The Hon Paul Scully MP  
Minister for Planning and Public Spaces  
GPO Box 5341  
Sydney NSW 2001

**Re: SSD-77825469 – Climate-related financial risk to NSW government of development in West-Roseville**

I am writing to submit the attached document in response to SSD-77825469, which proposes residential development on Pockley Avenue, Roseville.

**Figure 1: West-Roseville precinct enclosed by red, with three exits signposted**

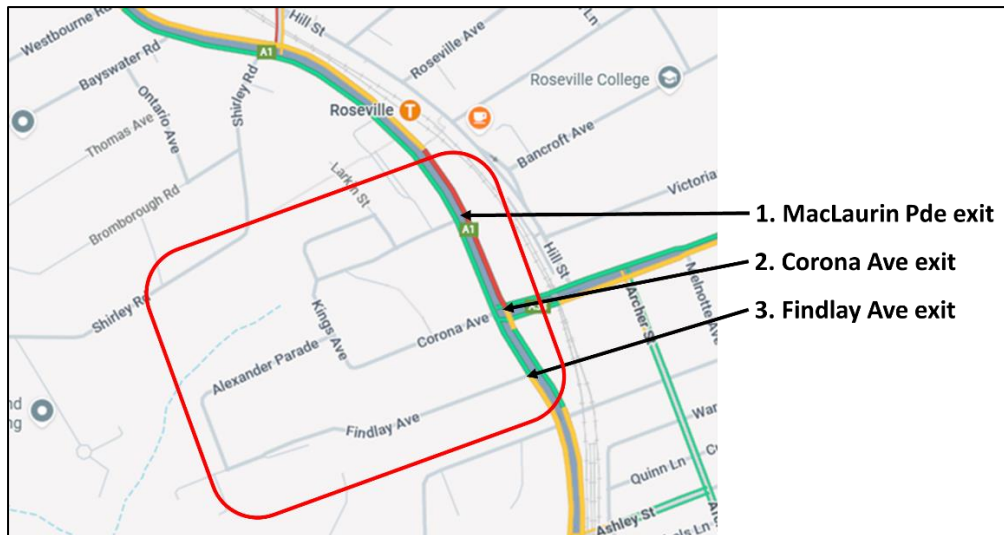
**There are only three existing exits** to the Pacific Highway (See Figure 1):

- MacLaurin Parade (the sole southbound exit),
- Corona Avenue, and
- Findlay Avenue.

The MacLaurin Parade–Pacific Highway intersection is the only safe right-turn option for residents west of the precinct, including Findlay Avenue (Willoughby Council). This intersection is frequently blocked by southbound traffic, forcing vehicles to queue on the Highway (see Figure 2). U-turns at MacLaurin Parade further worsen congestion as drivers attempt to bypass delays at Boundary Street.

A fourth exit is proposed via a new road from Shirley Road to Pockley Avenue. However, this route is constrained by delays at the Shirley–Pacific Highway intersection, which often requires 2–3 traffic light cycles to clear. Moreover, in a fire emergency, access to Findlay Avenue would likely be blocked, as the lower end of Alexander Parade—providing access to Findlay—was closed by emergency services during the 1994 bushfire event. This would effectively reduce the number of viable exits back to three, even with the proposed new road.

**Figure 4: Comparison of existing and proposed dwellings with safe evacuation thresholds**

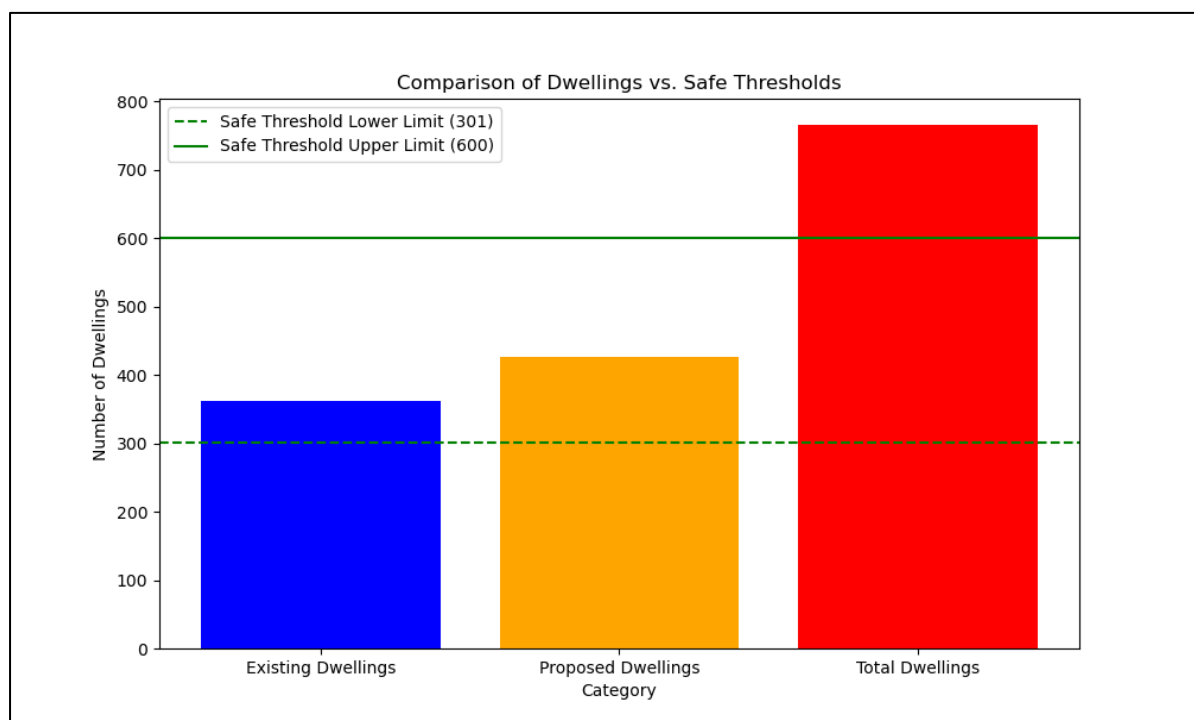
only **three exit roads** should accommodate a **maximum of 301–600 households** to ensure safe evacuation. The West-Roseville precinct currently has **766 homes** planned and existing—well above this threshold (see Figure 4)—and an additional **686 car spaces** are proposed, more than doubling the number of vehicles in the area. This figure does not include overflow street parking, which is expected to increase significantly.
